**RE: Thorndike Place, Dorothy Road, Arlington, Massachusetts – Preliminary Review of Applicant’s Groundwater Mounding Analysis**

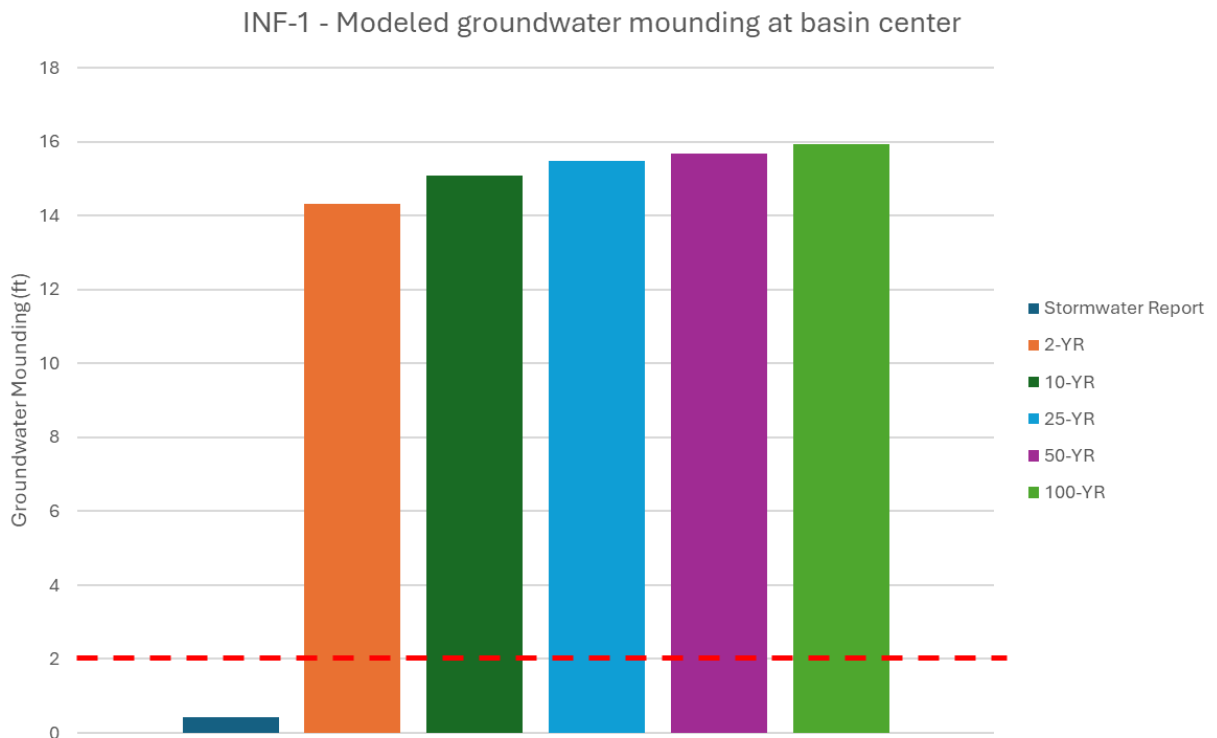
Based on MMA's review, the Applicant appears to misinterpret guidance provided by the Mass. SW Handbook relative to conducting (groundwater) mounding analyses. Specifically, the Applicant incorrectly views a reference to *Required Recharge Volume* (RRV) used in the Mass. SW Handbook as a direct instruction for designing a specific loading scenario under which to evaluate resultant groundwater mounding. In the Mass. SW Handbook's discussion of mounding analysis requirements, the RRV is not being singularly used to define a specific volume of infiltration produced by an individual, hypothetical storm event, as the Applicant represents in their mounding analysis. Instead, the RRV term is being used in the Mass. SW Handbook to more generally refer to the volume of internal storage provided by the proposed infiltration practice that would fill during a storm and slowly drain via exfiltration/infiltration.

In MMA's experience, the common accepted practice for conducting mounding analyses that meet Mass. SW Handbook requirements is to use infiltration rates ***and durations*** representative of the largest (i.e., lowest probability) design events for which rate control is being provided. This approach is logical because, as acknowledged in BSC's 2021 Report, severe groundwater mounding can result in adverse hydraulic impacts that may reduce exfiltration/infiltration rates. This effect may, in turn, compromise the ability of a system to provide the intended rate control function. Our position on this matter is supported by the Mass. SW Handbook excerpts provided below, which generally refer to the need to illustrate full drainage of system storage under contemplated storm events, not just drainage capability under an artificial case based on the specific volume definition of the RRV:

Ultimately, the Applicant's misinterpretation of Mass. SW Handbook guidance causes their mounding analysis to be conceptually flawed and unreliable in supporting key assumptions regarding system performance. In effect, the Applicant's analysis only provides an answer to a very specific and inappropriately narrow question: *can the proposed system exfiltrate/infiltrate a volume of water equal to the RRV without indications of adverse effects from groundwater mounding?* In actuality, the Mass. SW Handbook seeks answers to different questions that pertain more directly to evaluating

proper system functionality, for example: *can the proposed system completely drain during storm events (i.e., within the required 72-hour period) in consideration of potential adverse effects from groundwater mounding, and is it valid to assume exfiltration/infiltration rates will not be adversely impacted during storm events by groundwater mounding when conducting HydroCAD simulations to evaluate rate control performance?*

Though MMA does not endorse the Applicant’s modeling approach (i.e., utilization of the Hantush analytical model) or agree with certain inputs to the model used by the Applicant (e.g., assumed values of horizontal hydraulic conductivity and specific yield), the framework is *generally* useful for illustrating concerns relative to groundwater mounding potential associated with the proposed design. The figure below compares the Applicant’s peak mounding height prediction (referred to as “Stormwater Report”) for the INF-1 system to additional mounding height predictions based on estimated infiltration durations for the 2-, 10-, 25-, 50-, and 100-year, 24-hour storm event scenarios<sup>1</sup> evaluated using HydroCAD, which assumes no infiltration rate reductions due to groundwater mounding. All inputs to the model aside from the infiltration duration are unchanged (i.e., the same as those used in the “Stormwater Report” case). The dashed red line depicts the 2.02-feet of vertical separation between the bottom of INF-1 and the ESHGW elevation currently proposed by the Applicant.

The Applicant predicts minimal mounding because they use the RRV to estimate the infiltration duration (0.051 days), and the resultant estimated duration is significantly shorter than infiltration durations estimated for the contemplated storm events (ranging from approximately 2 days for the 2-year event to approximately 2.3 days for the 100-year event). When the longer, storm-specific infiltration duration estimates are used instead, the Applicant's model predicts tremendous groundwater mounding with levels rising to unrealistic heights that significantly exceed the proposed system bottom. Consistent with the position expressed in the BSC 2021 Report, when groundwater is predicted to rise to this degree, it is an indication of a strong potential for adverse hydraulic effects that would extend system drainage times, thus warranting further analysis and potentially design adjustment. Due to the Applicant's misinterpretation of the Mass. SW Handbook, this potential—as well as the potential for other adverse effects associated with groundwater mounding—has simply not been recognized or addressed.
